Executive Director's Recommendation

Commission Meeting: April 5, 2018

PROJECT Building Exterior, Vestibules, and Site Improvements National Air and Space Museum Independence Avenue at 6th Street, SW Washington, DC	NCPC FILE NUMBER 7585
SUBMITTED BY Smithsonian Institution	NCPC MAP FILE NUMBER 1.41(38.00)44713
REVIEW AUTHORITY Federal Projects in the District per 40 U.S.C. § 8722(b)(1) and (d)	APPLICANT'S REQUEST Approval of preliminary and final site and building plans
	PROPOSED ACTION Approve preliminary and final site and building plans
	ACTION ITEM TYPE Staff Presentation

③ Southwest Corner Delta Solar Fountain - Sections - Final Design

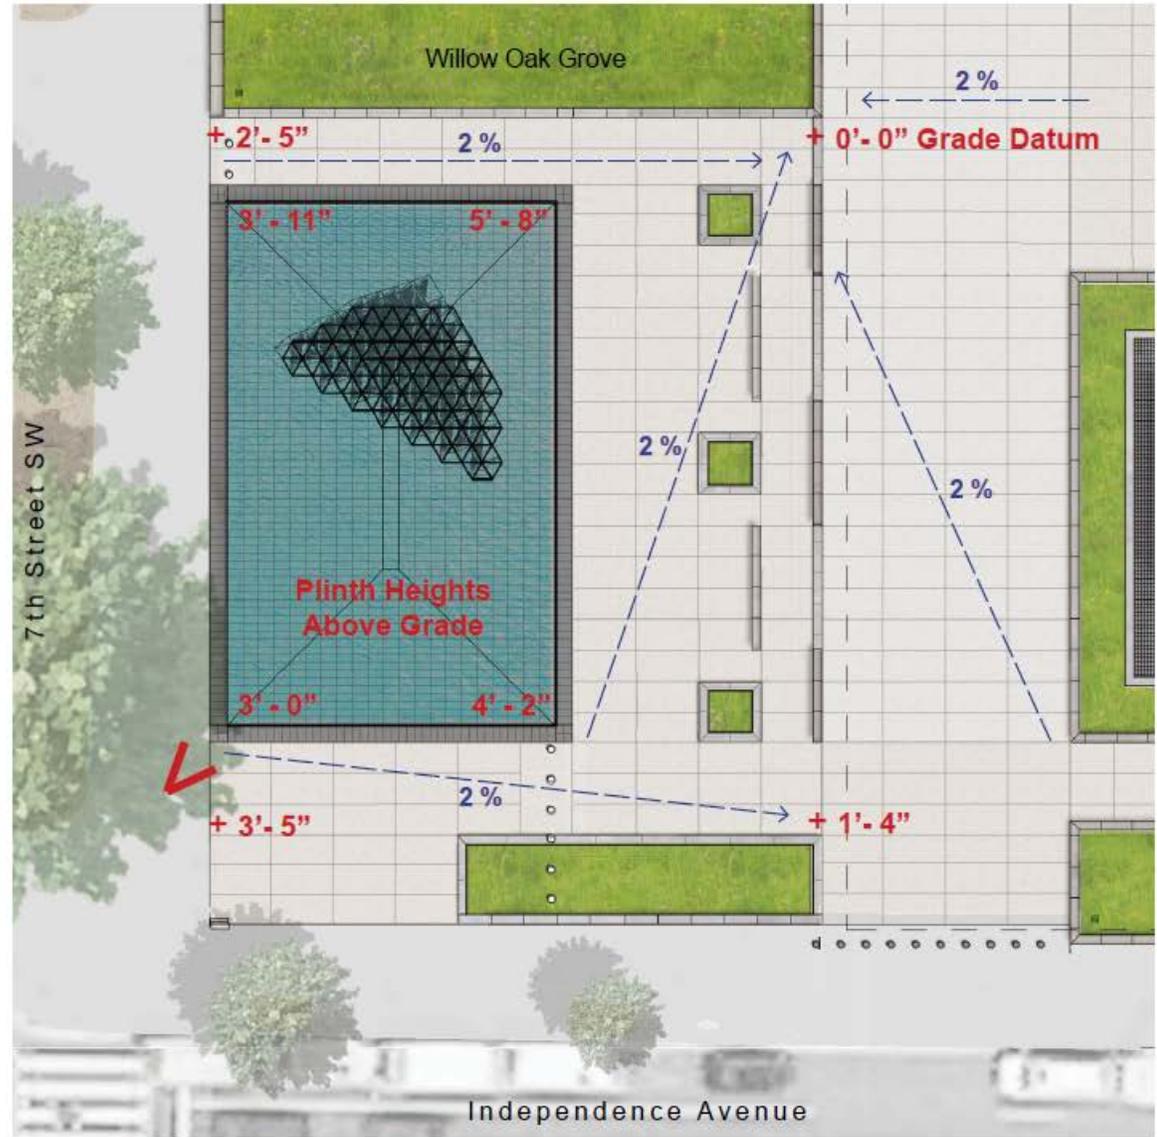
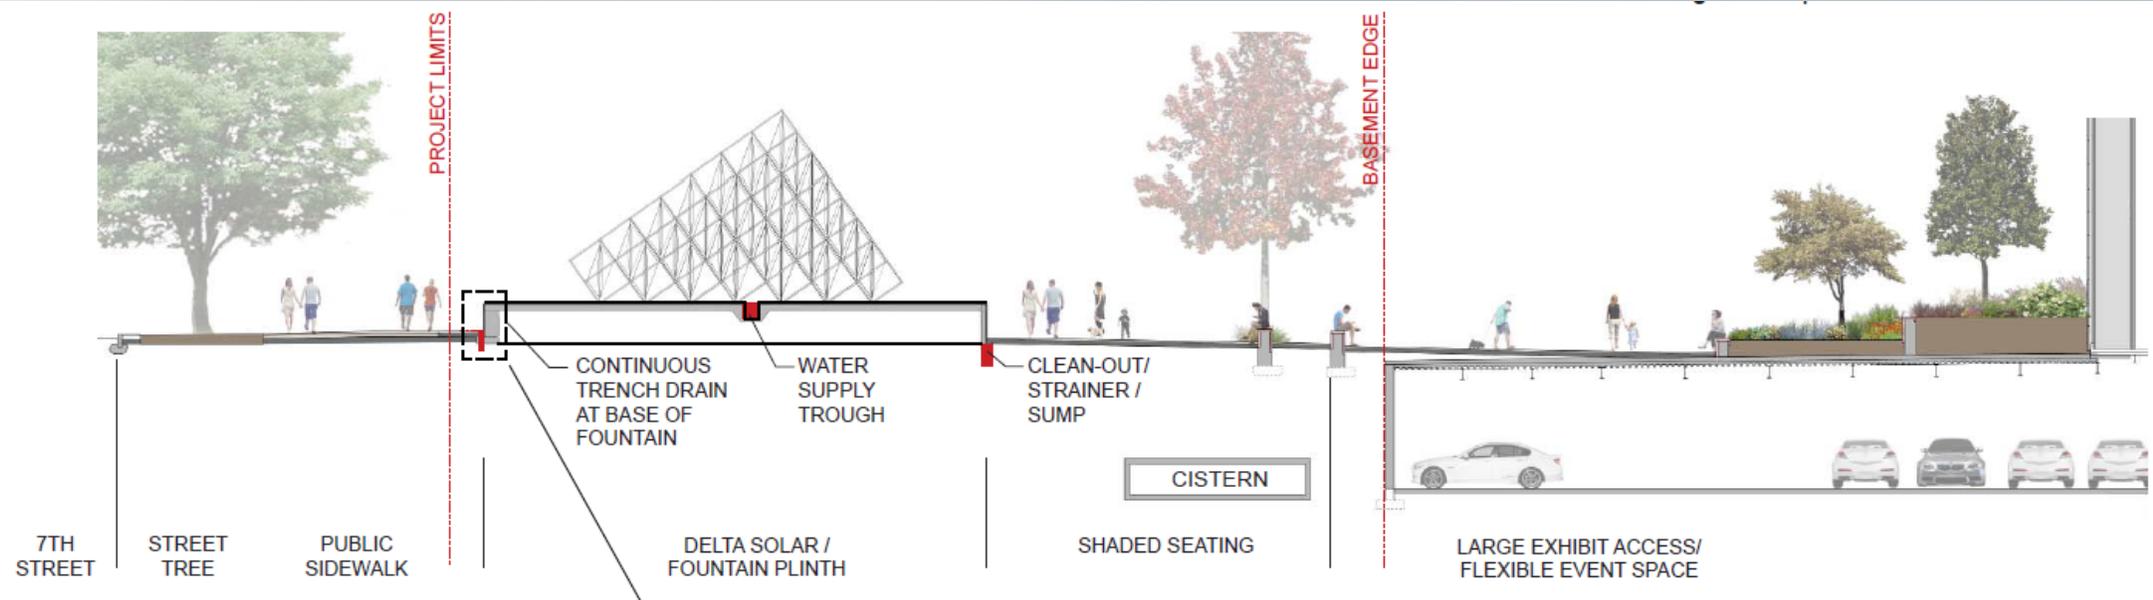
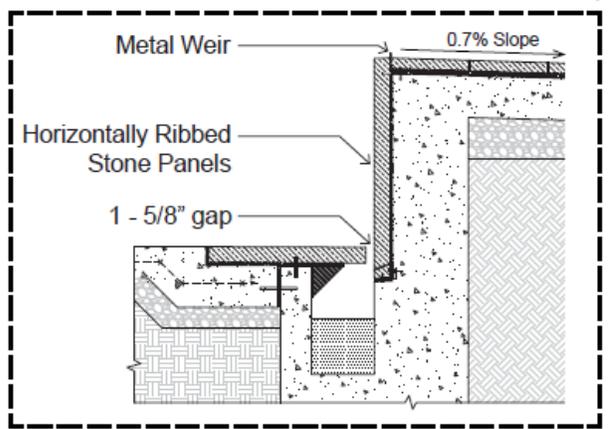
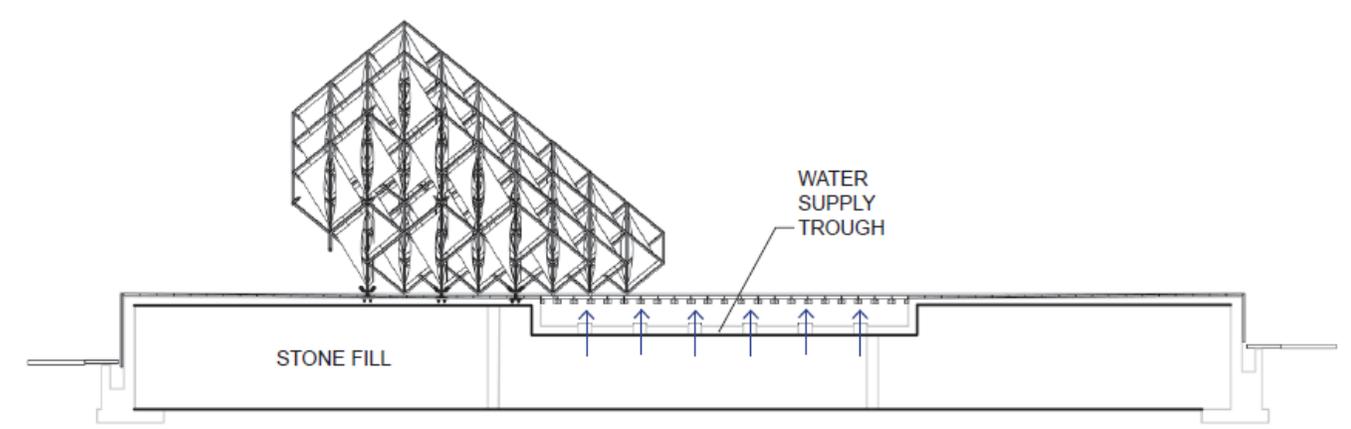
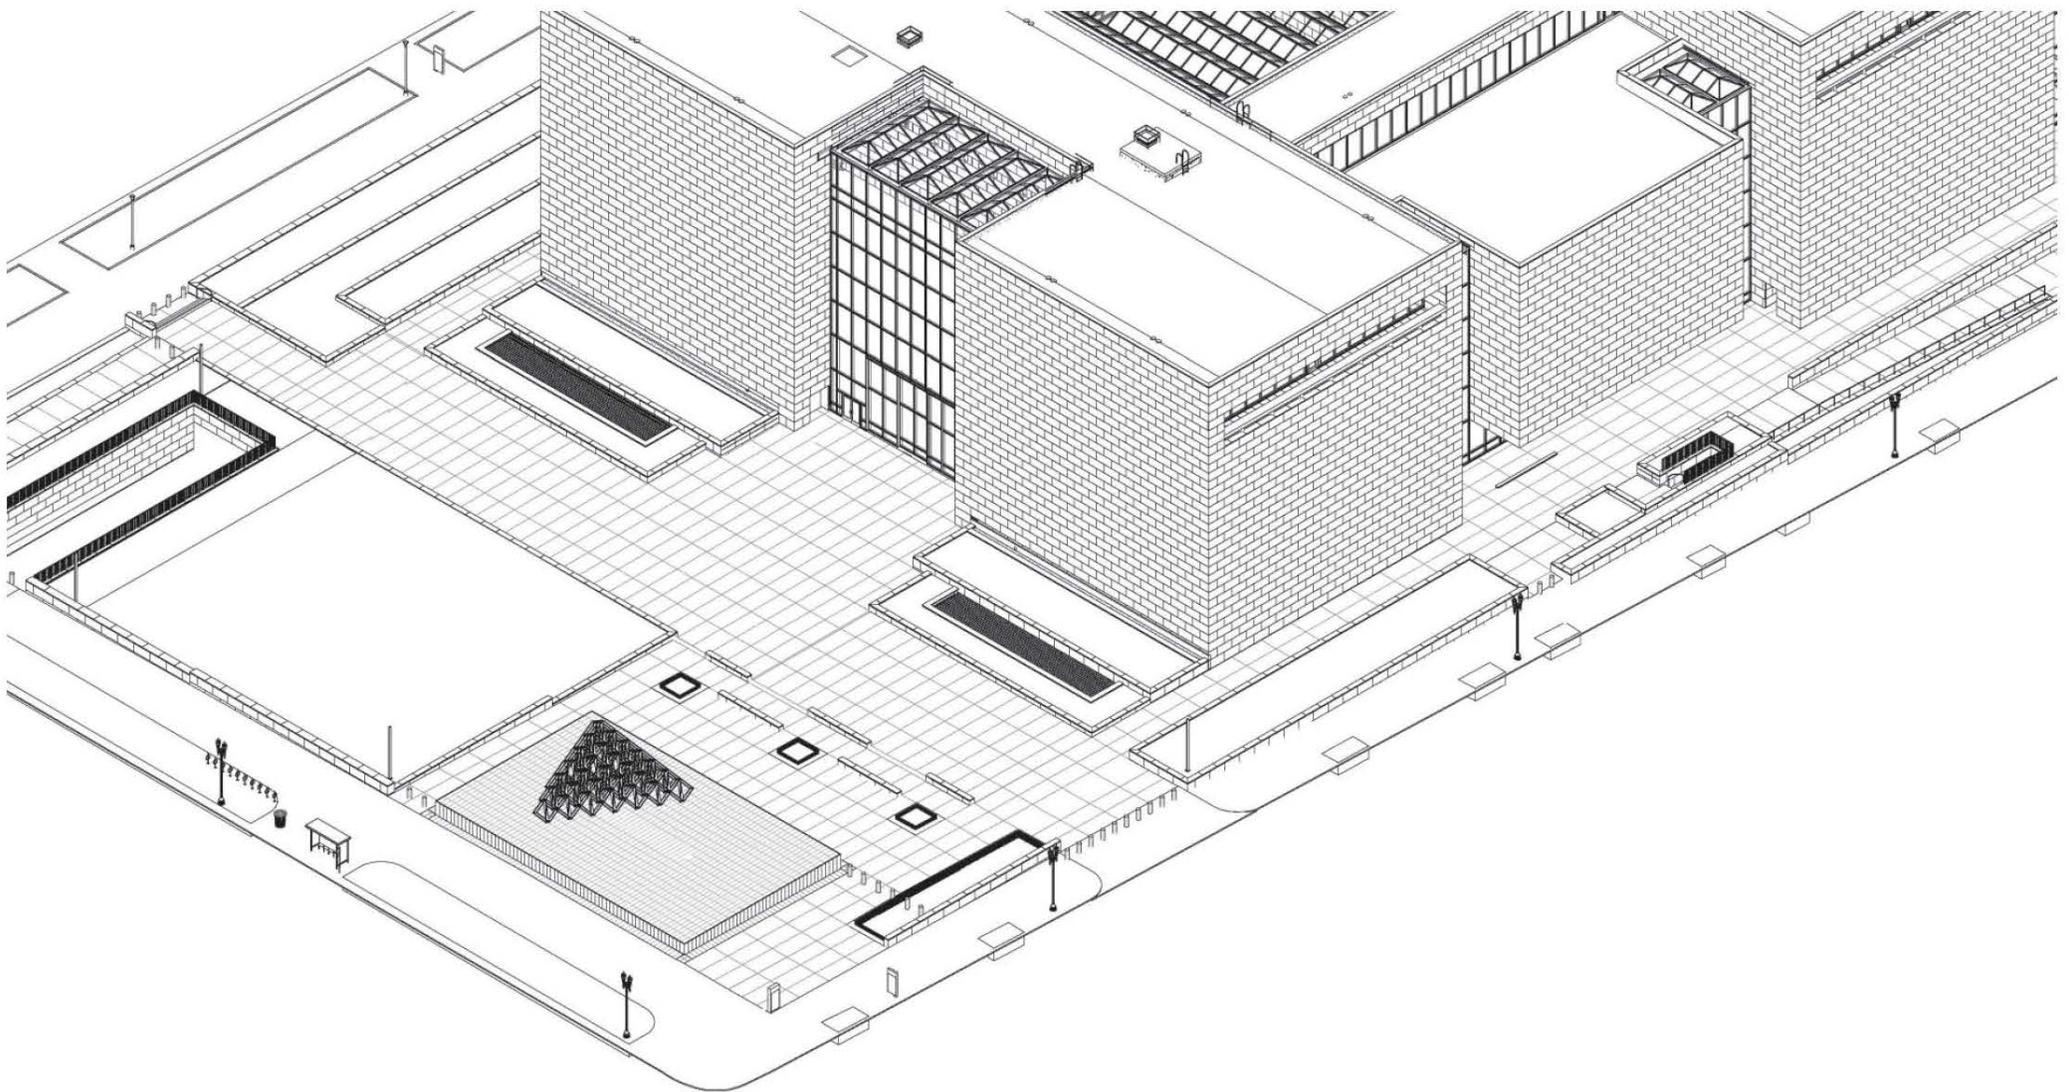
Water Feature: The final design incorporates an animated water wall on all four sides of the Delta Solar plinth, emanating from a shallow reflecting pool that slopes toward the center. The fountain will be operational for the majority of the year. During the coldest weather the fountain will be turned off to prevent the thin film of water from freezing.

The plinth vertical panels are composed of a horizontally-ribbed stone which will animate a thin film of water flowing over the surface of the plinth. The water supply will be located under the stone panels in an inlet trench access panel in the center of the plinth which is designed to create a minimum-depth surface of water over its top. The water will flow over a continuous stainless steel “infinity edge” down the walls of the plinth. The plinth will be clad in dark “Mesabi Black” granite panels with Diamond 8 finish (honed finish). The dark granite will highlight the visibility of the flowing water film. The rectangular stone paver panels on the fountain plinth will be 15 by 30 inches, resembling the proportion of the building cladding, which individual panels measure 5 feet wide by 2.5 feet tall. The same granite stone pavers will be provided on the apron around the fountain, but with a thermal finish for slip resistance, which is a different finish from the plinth. A continuous trench drain will surround the base of the fountain.

The plinth height will vary due to the existing grading. The plinth will have a minimum height of three feet (3'-0") at the southwest corner for perimeter security purposes. The maximum height will be five feet eight inches (5'-8") at the northeast corner. The higher elevation of the east side of the plinth responds to the topography but also will provide a respite from the noise of the adjacent intersection of Independence Avenue and 7th Street SW, while preserving the required horizontal plane for the sculpture base. The proposed plinth will be approximately 84 feet long by 52 feet wide, similar to the existing shallow pool dimensions.

- **An infinity-edge water feature on the proposed plinth of the Delta Solar sculpture to create a welcoming entry to the museum and the National Mall along Seventh Street, and preserve the integrity of the sculpture.**

Southwest Corner Entry Bollard Enlargement - Dimensioned Plan - Final Design

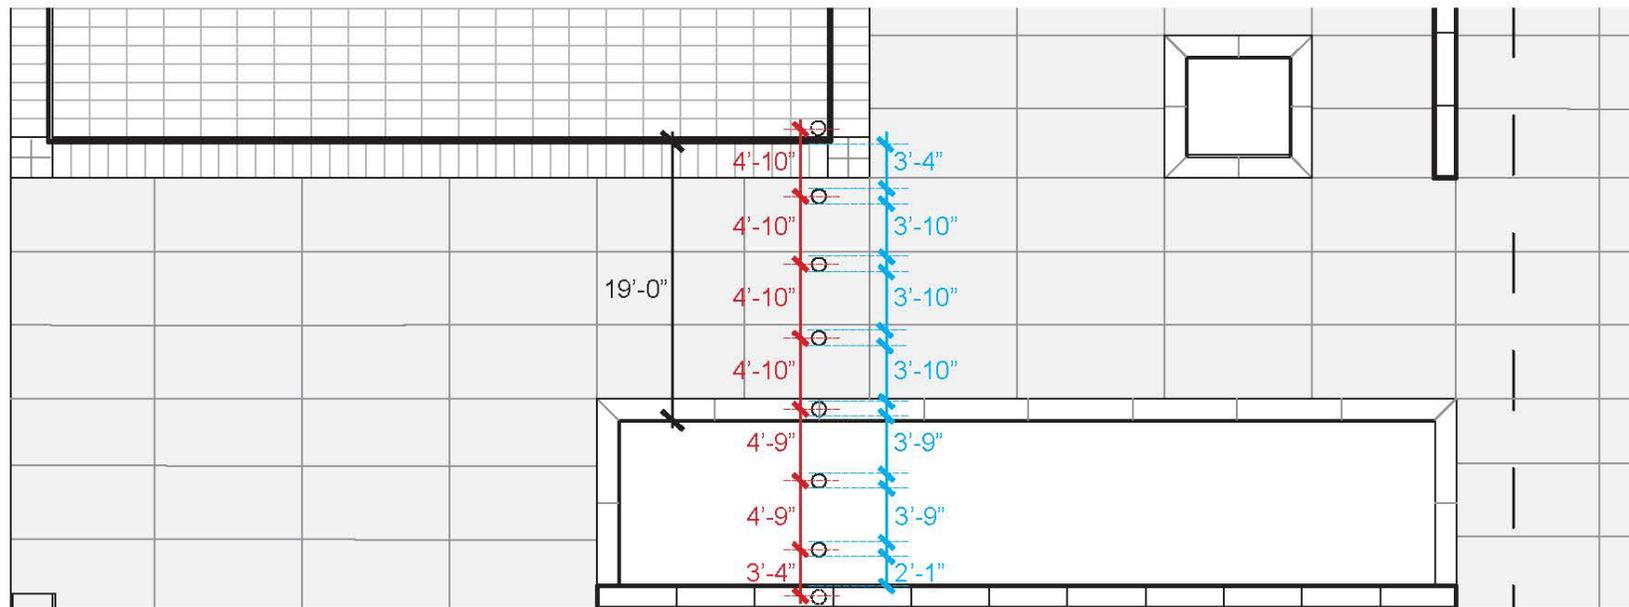
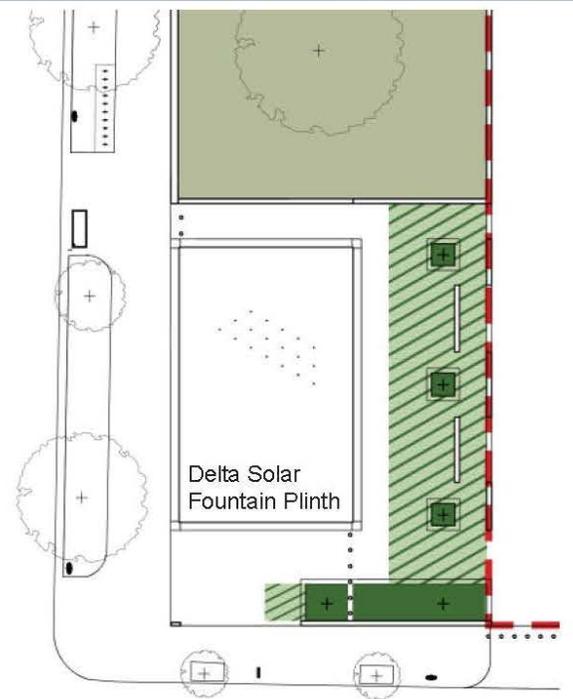
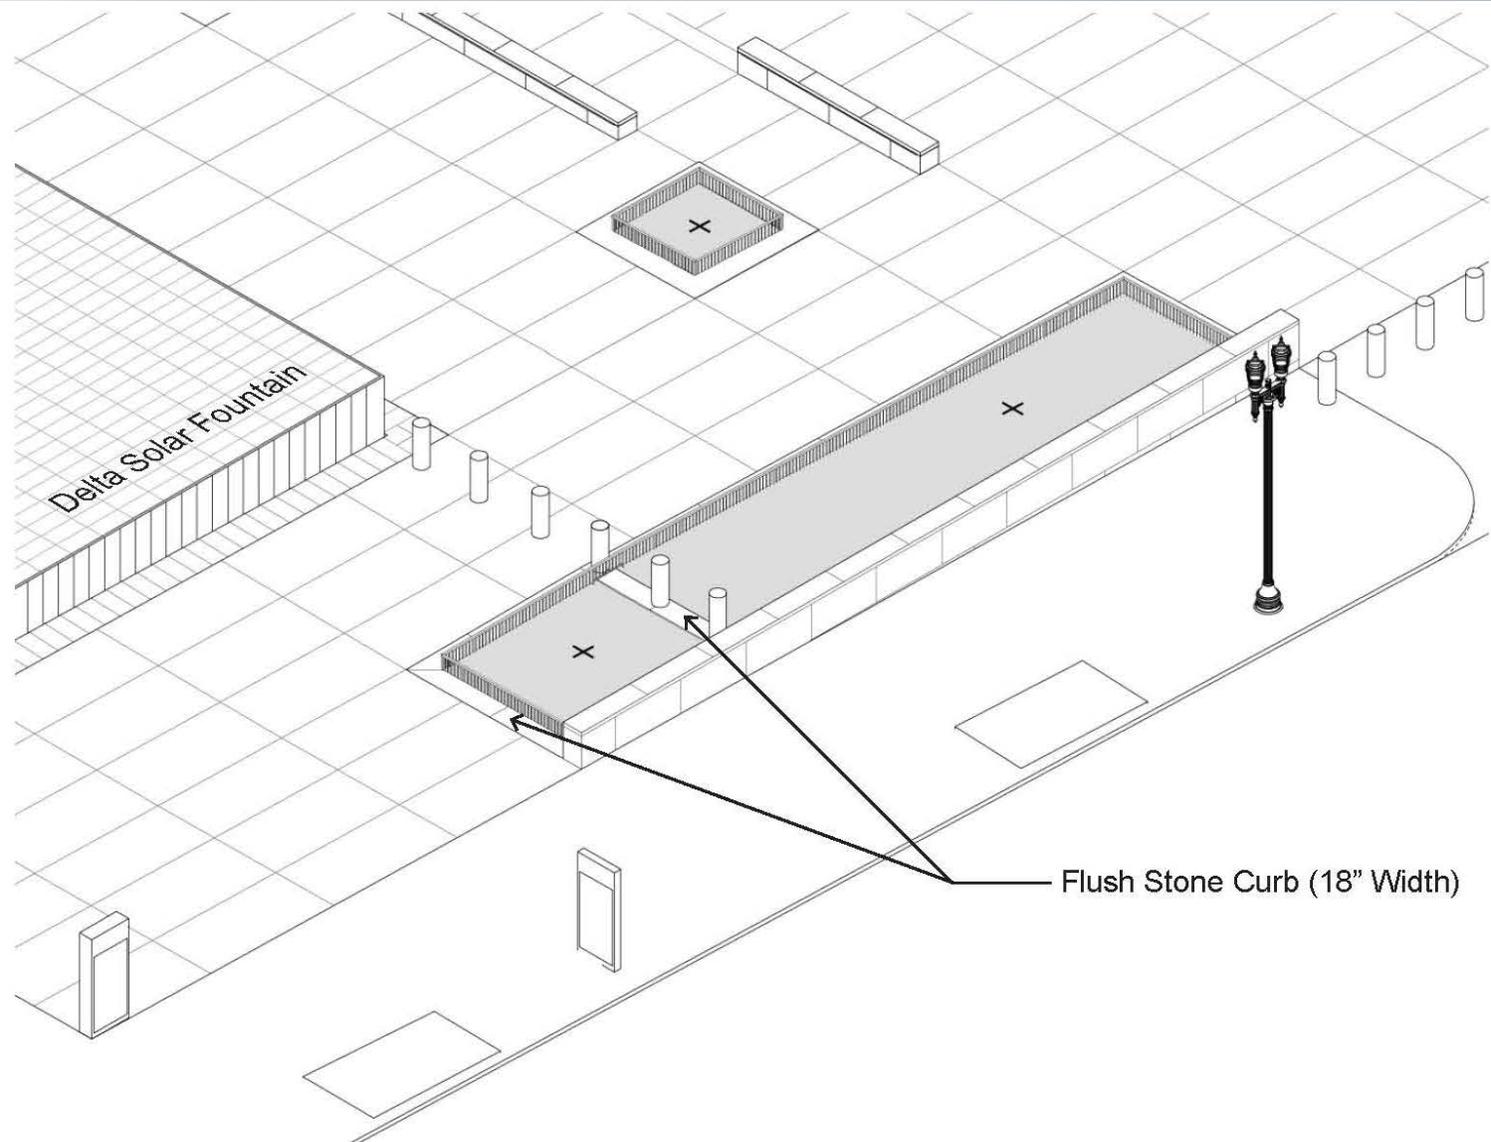
Requests that the Smithsonian continue to work with staff from NCPC and the U.S. Commission of Fine Arts (CFA) to find an alternative design solution for the three bollards proposed within the planter near the corner of Independence Avenue and Seventh Street, SW, such that the design is consistent with the building vocabulary and perimeter security throughout the site.

The final plans include a line of six bollards that align with the eastern edge of the fountain, and are perpendicular to the solid perimeter wall along Independence Avenue. Three bollards are located within the planting area. Staff is concerned that the bollards footing will prevent the roots of the proposed trees to connect. In addition, bollards within planters create an unusual condition that is not consistent with the rest of perimeter security elements on the museum grounds or the National Mall. Staff understands the desire to maintain an open and inviting corner, and recommends SI explore other more creative alternatives that provide a public amenity for visitors instead of using bollards at this special corner. Therefore, staff recommends that the Commission **request that the Smithsonian continue to work with staff from NCPC and the U.S. Commission of Fine Arts (CFA) to find an alternative design solution for the three bollards proposed within the planter near the corner of Independence Avenue and Seventh Street, SW, such that the design is consistent with the building vocabulary and perimeter security throughout the site.**
